Agenda Item: 7K Subject: Code for Canals Date: Dec 2/24

Agenda Item: 7 Subject: 592+582 Ranger Date: 12-2-24

Appeal of Departure Request 582 Ranger Lane & 592 Ranger Lane

Original Revision: Building

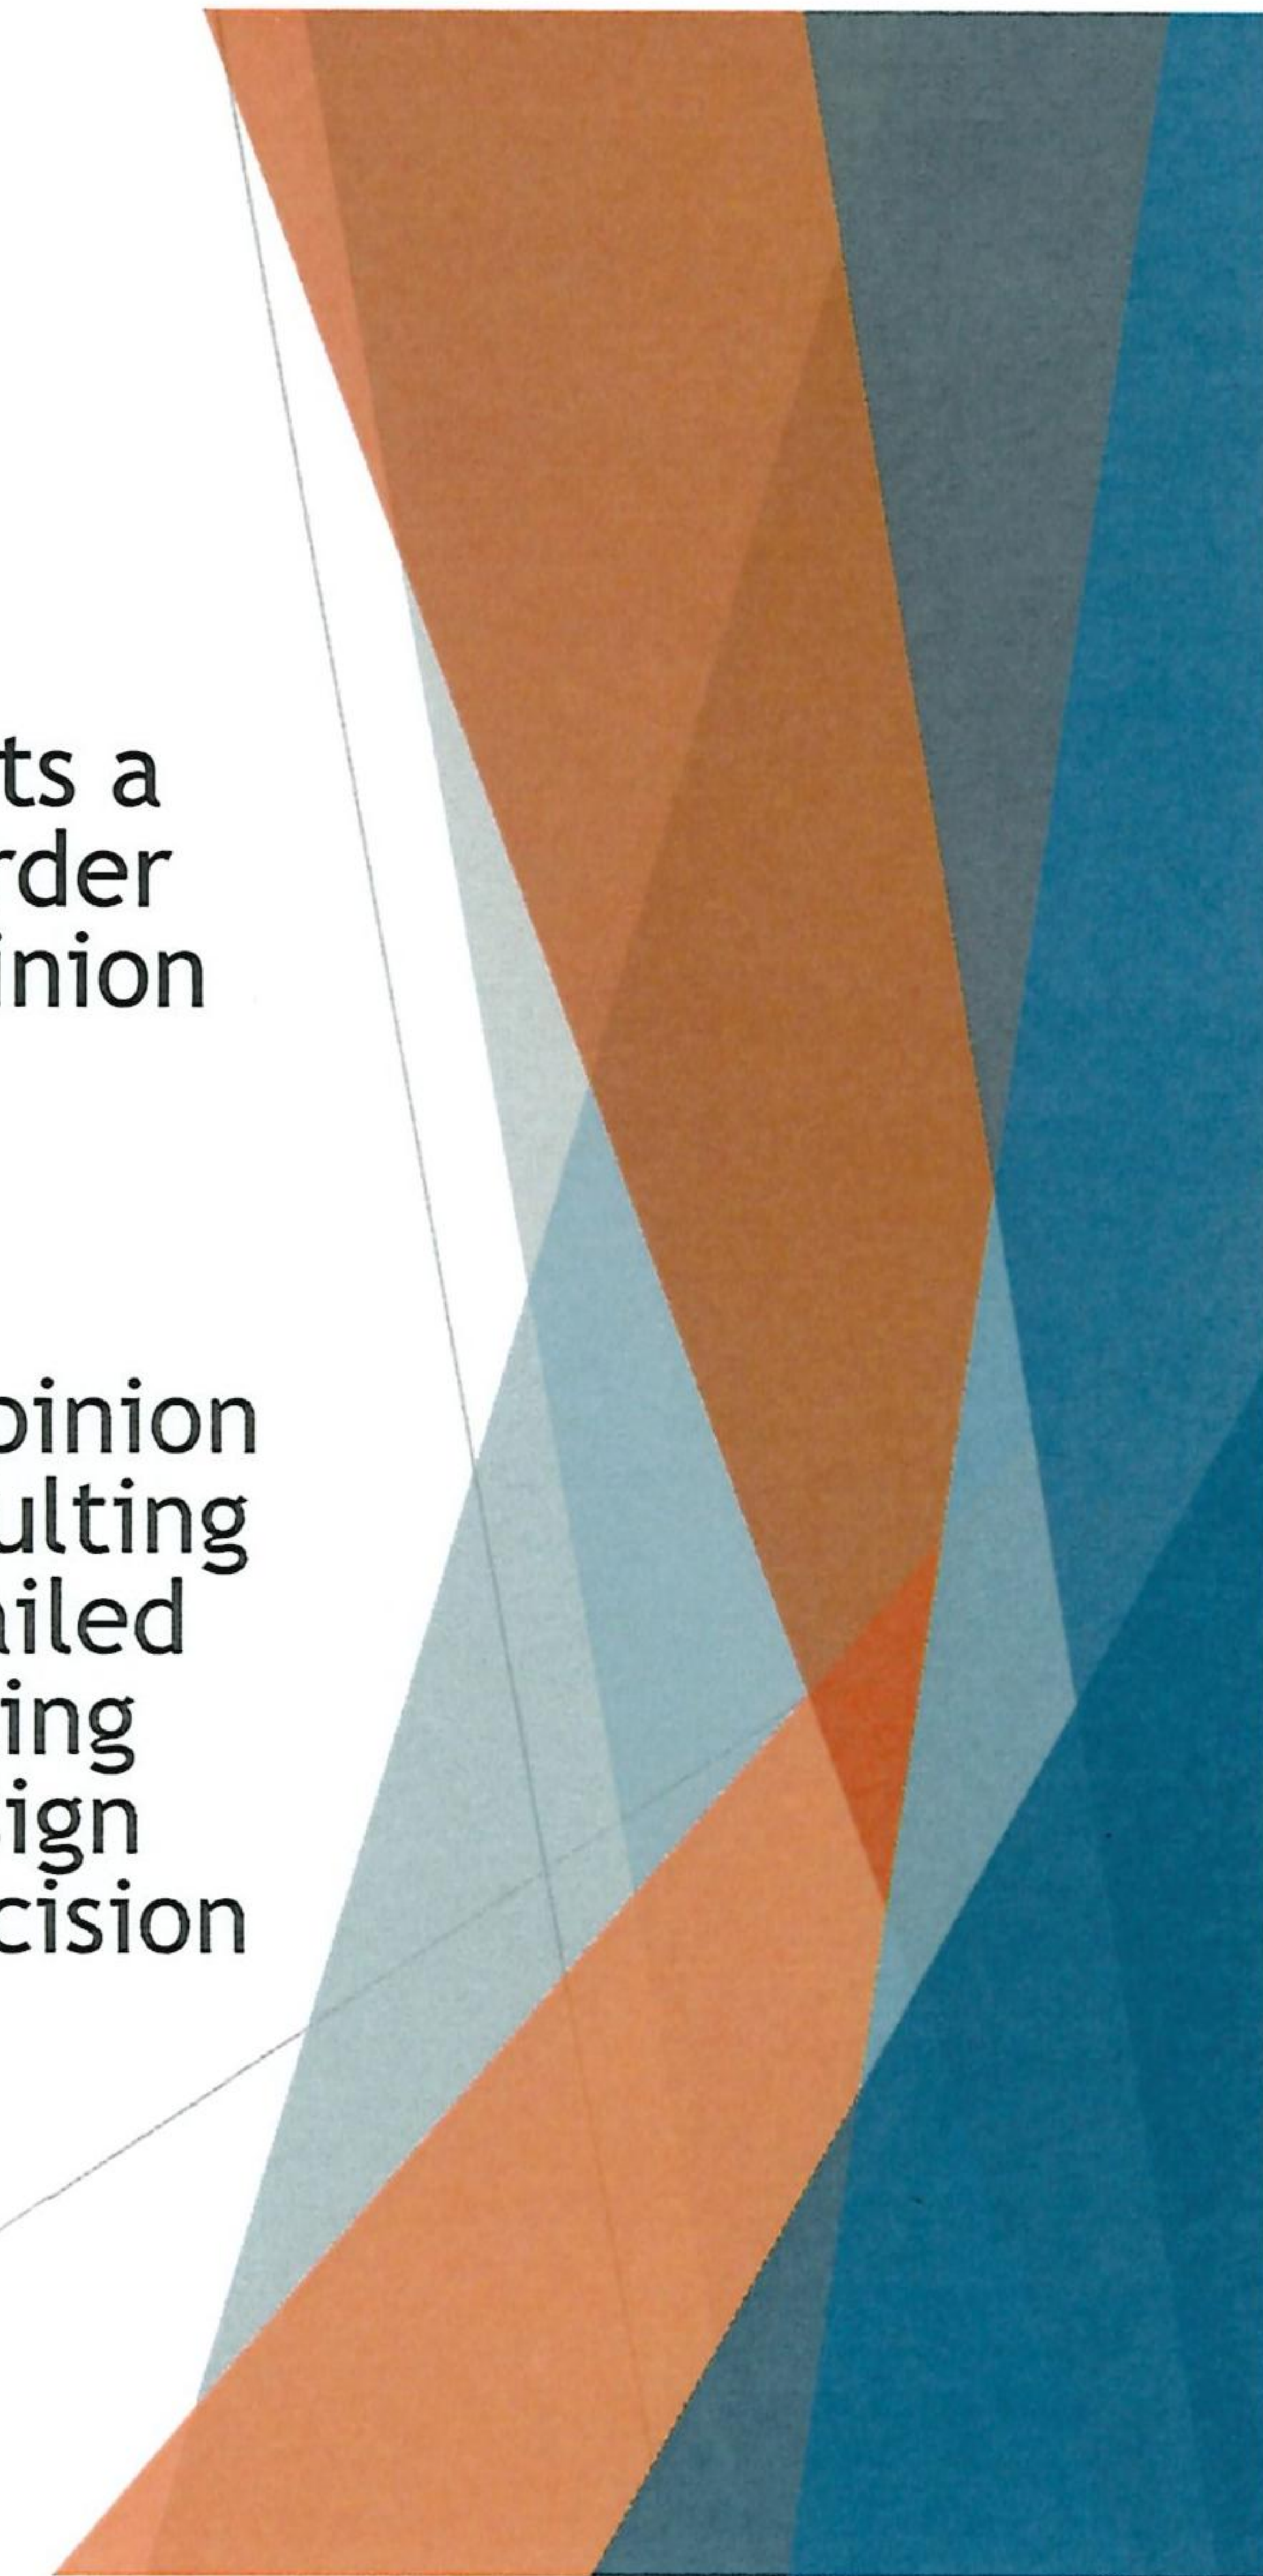
1. Please submit a detailed cross section of existing and proposed design of seawall showing location of pin piles and proposed "fix"

Revised Plans February 20, 2024 page 2

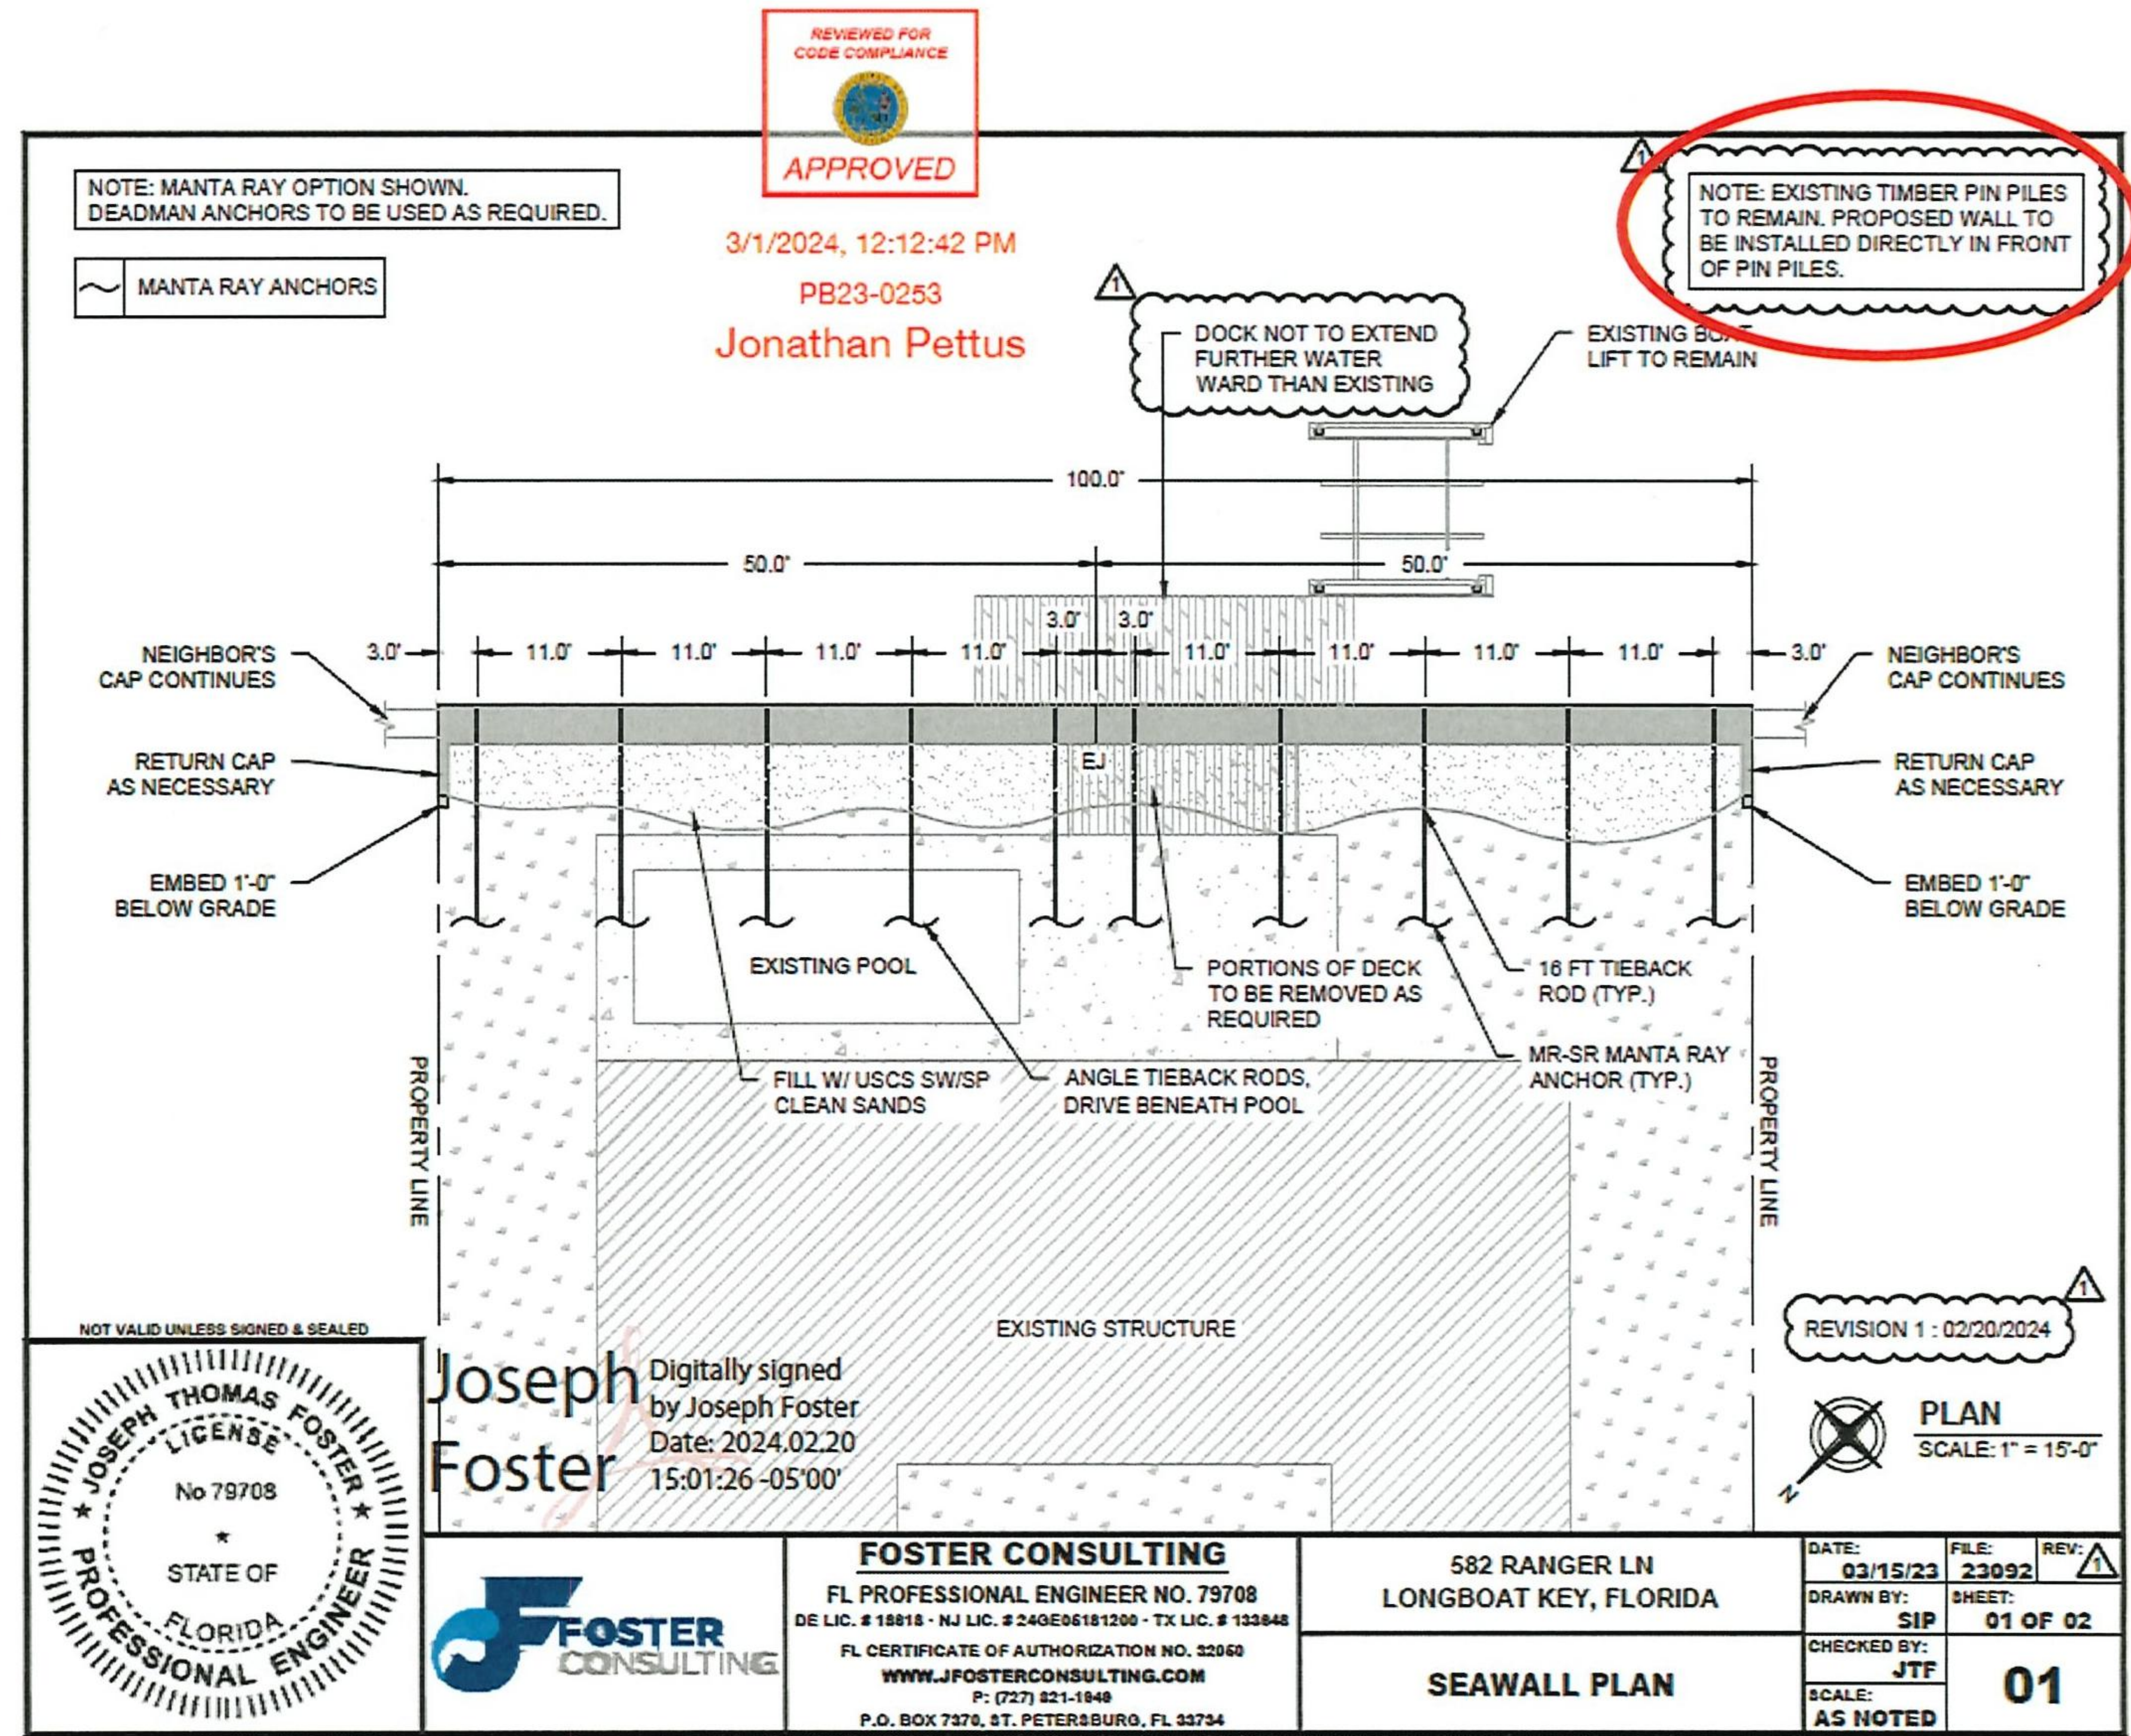
- ▶ Revised in response to Town's Building Plan Review

Existing timber pin piles to remain. Proposed wall to be installed directly in front of pin piles.

Revised Plans

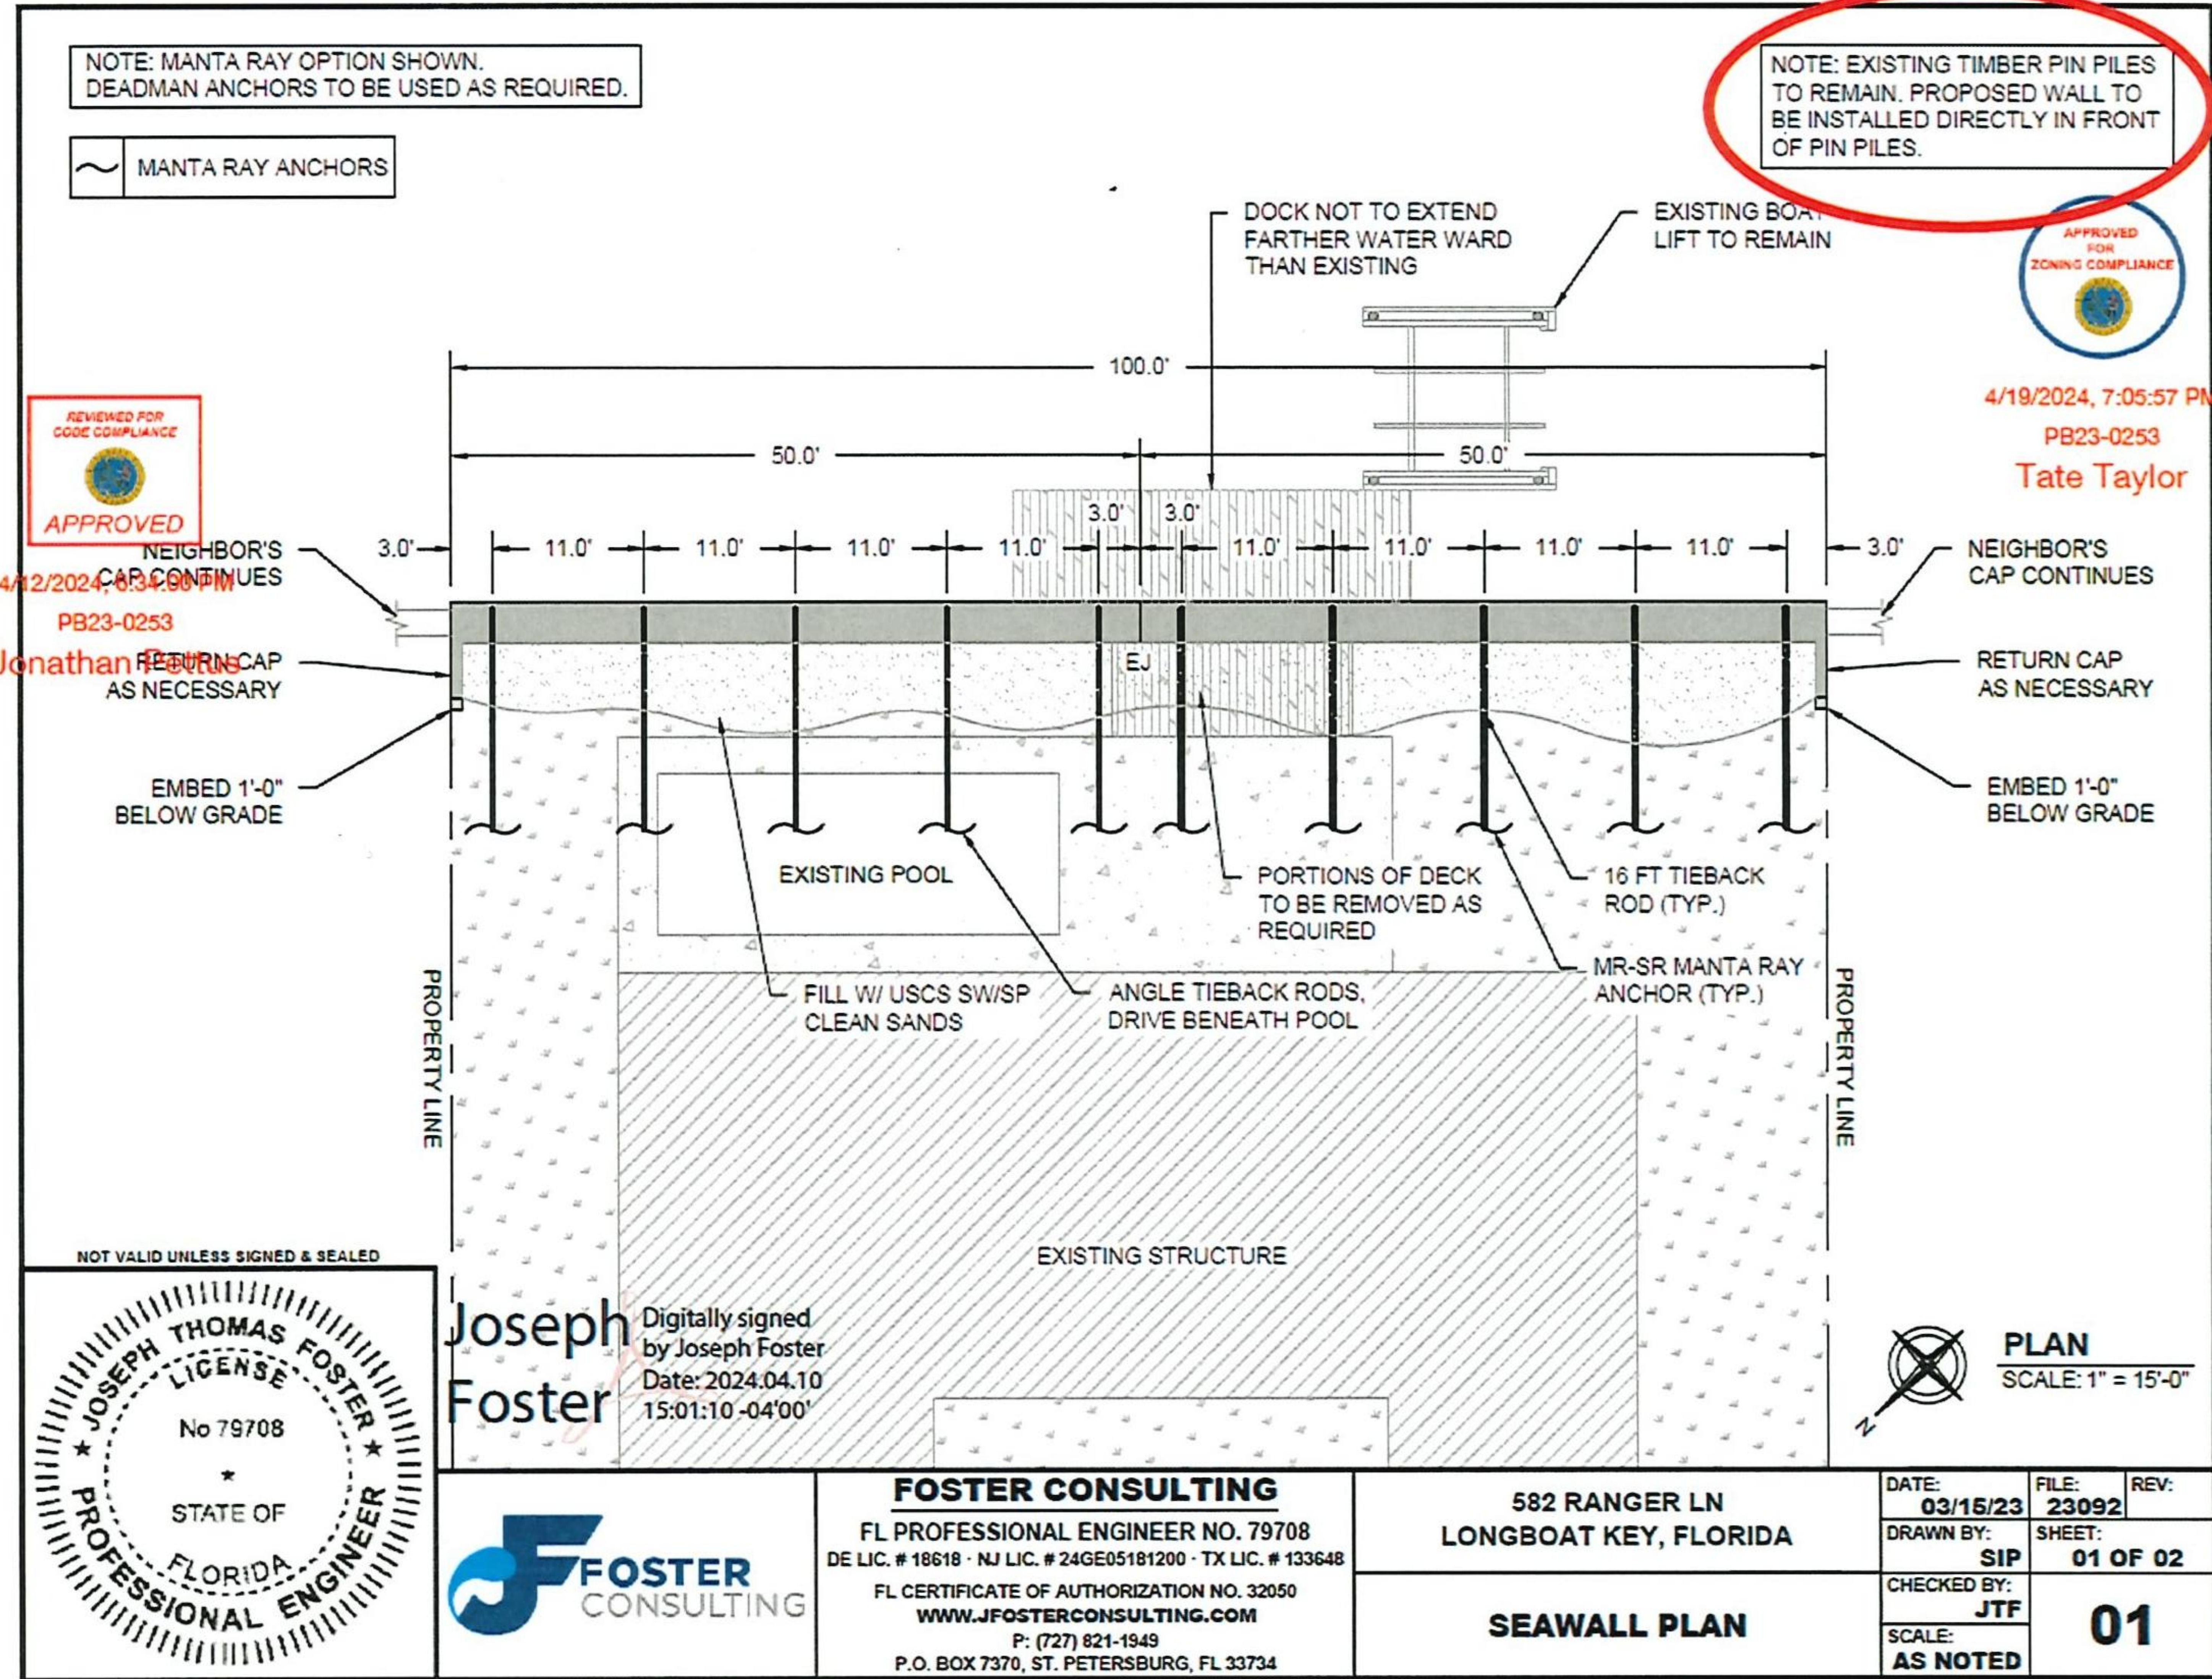
- ▶ Revised to widen the top of the seawall cap from 28" to 36"

Plans still note that existing timber pin piles to remain. Proposed wall to be installed directly in front of pin piles.
